# ACCESS PERMIT APPLICATION

Permit # 21-16  
Parcel ID: KR 952

Description of Project: New curb cut/access for subdivision (Lot 11) Is property in floodplain? No

DRAWING NO. <b>S-4</b>
SHEET 4 OF 11

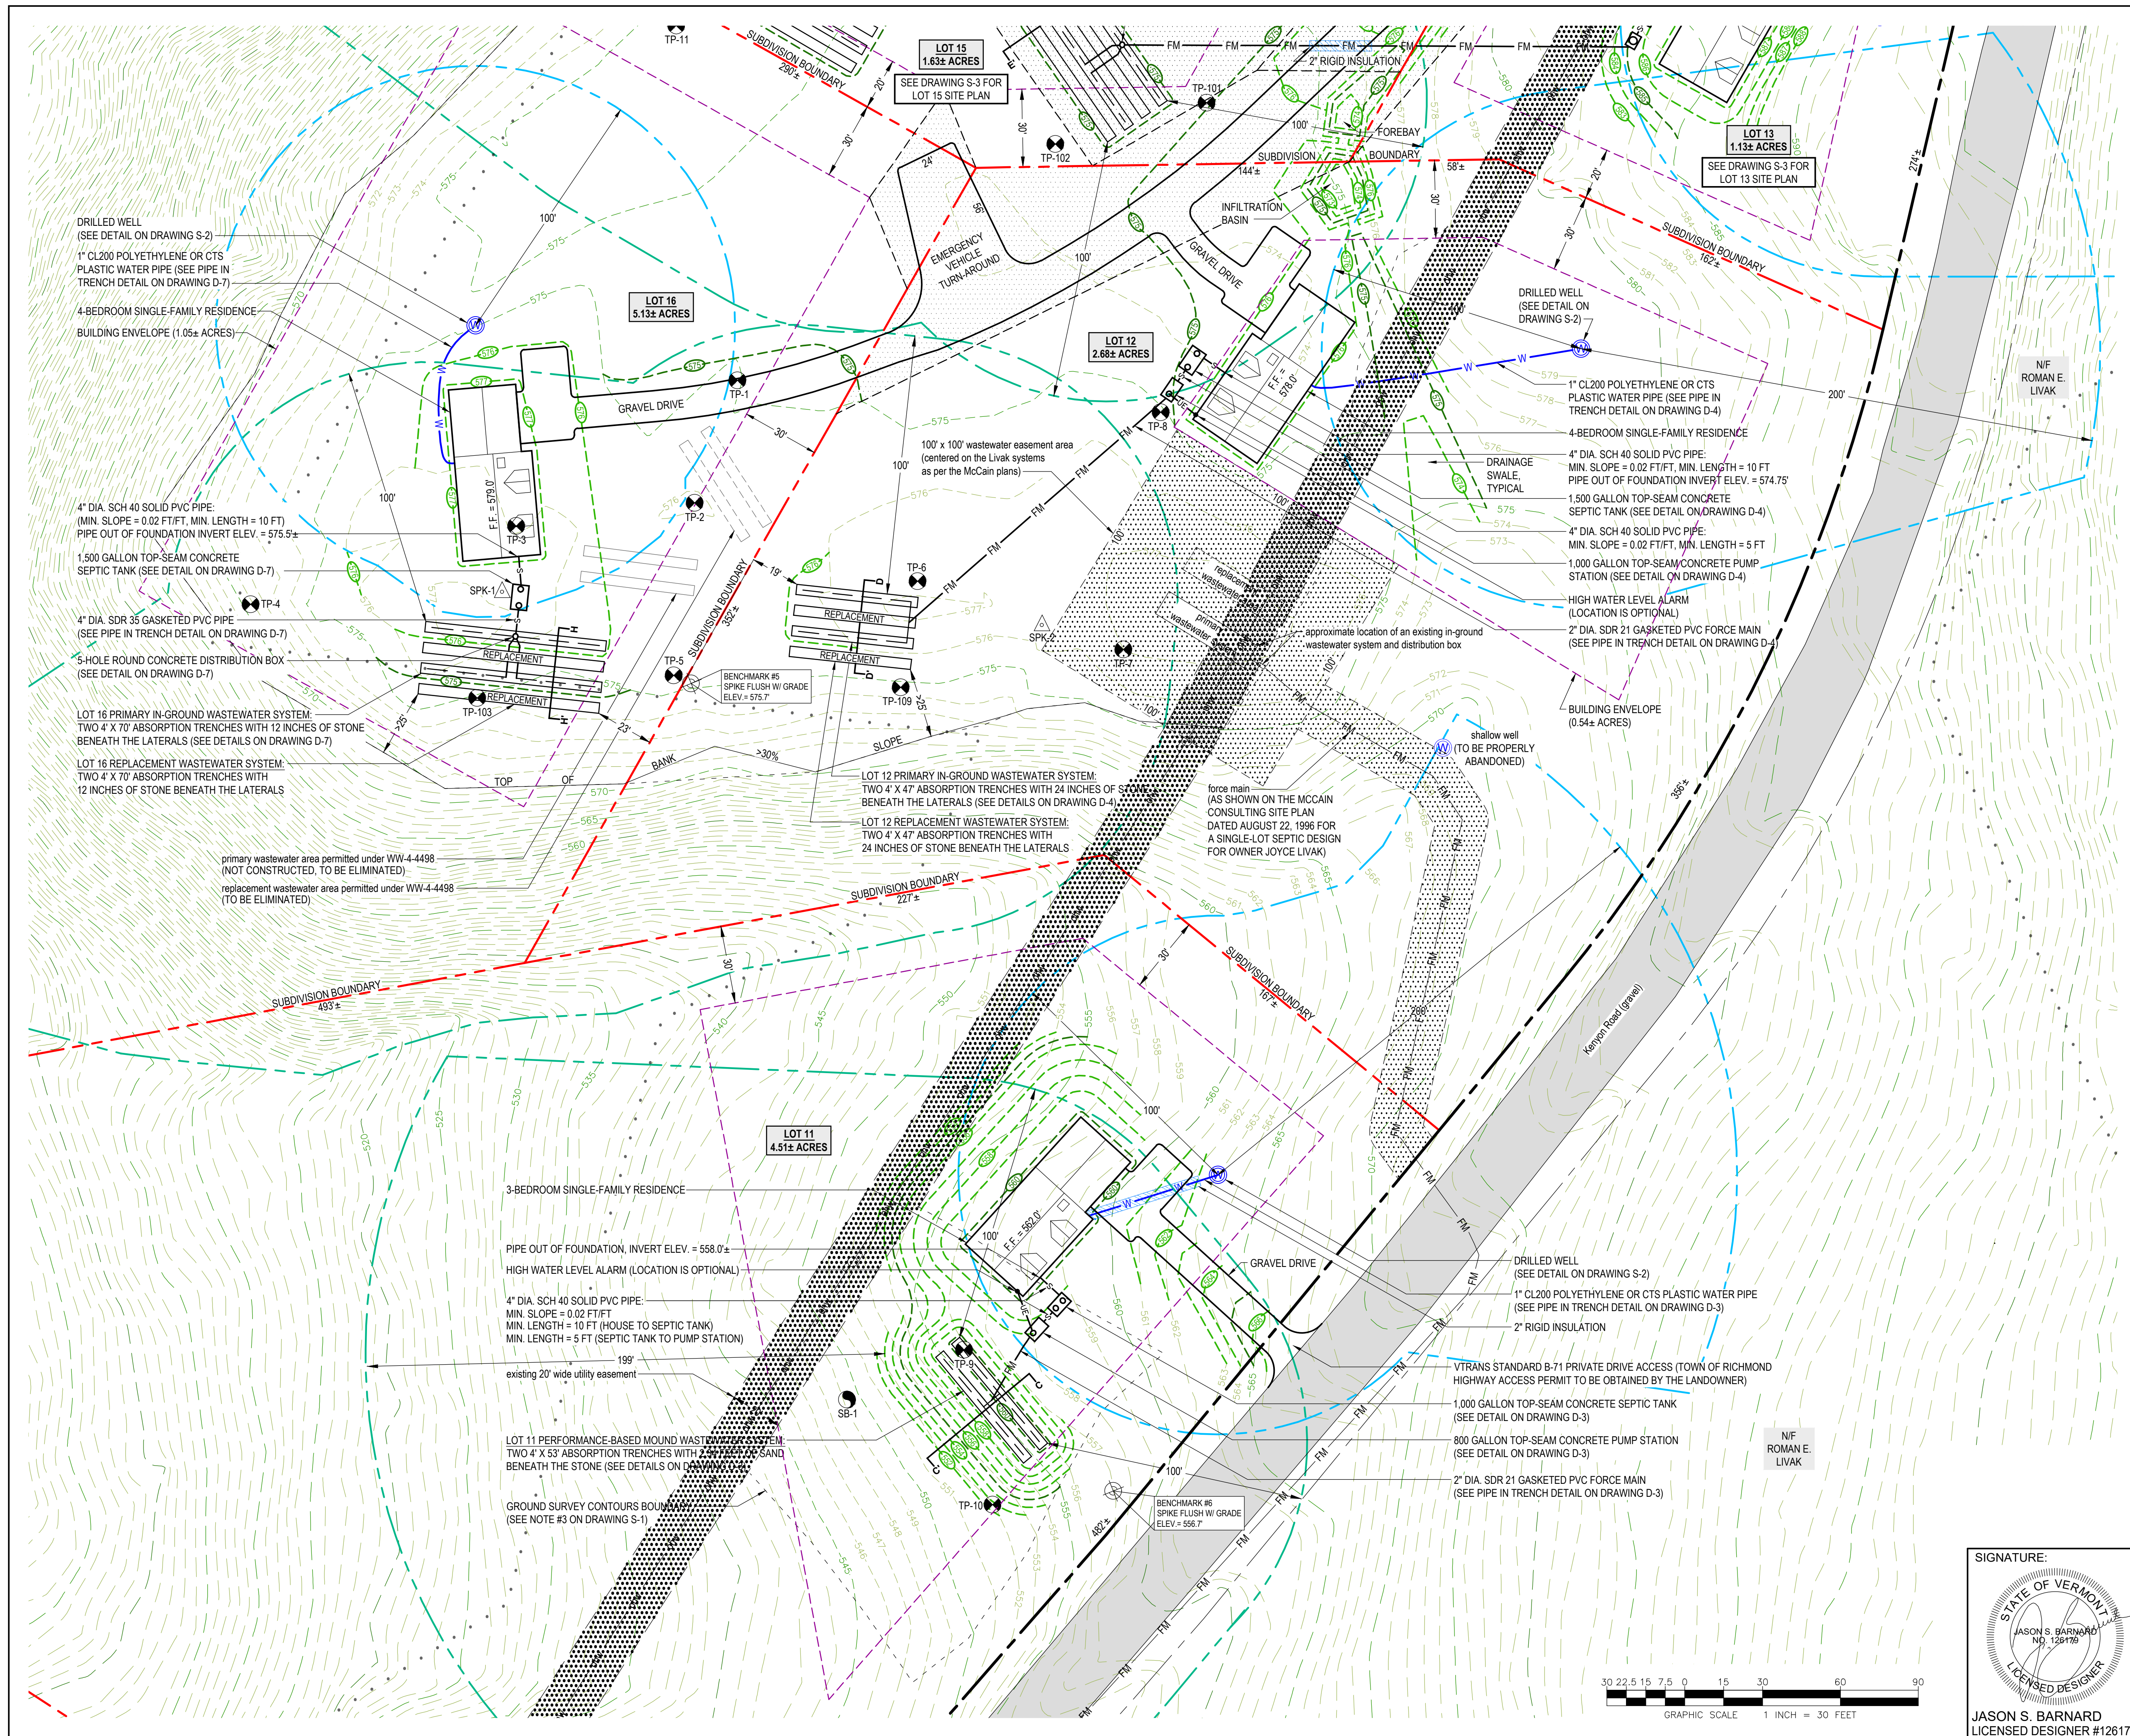
Comments: SIGHT LINE FROM ACCESS LOOKING NORTH IS 375' Additional comments on reverse

Highway Department Comments: SIGHTLINE FROM ACCESS LOOKING SOUTH IS 630'  
NO CULVERT REQUIRED. SIGHTLINES ADEQUATE FOR ACCESS.
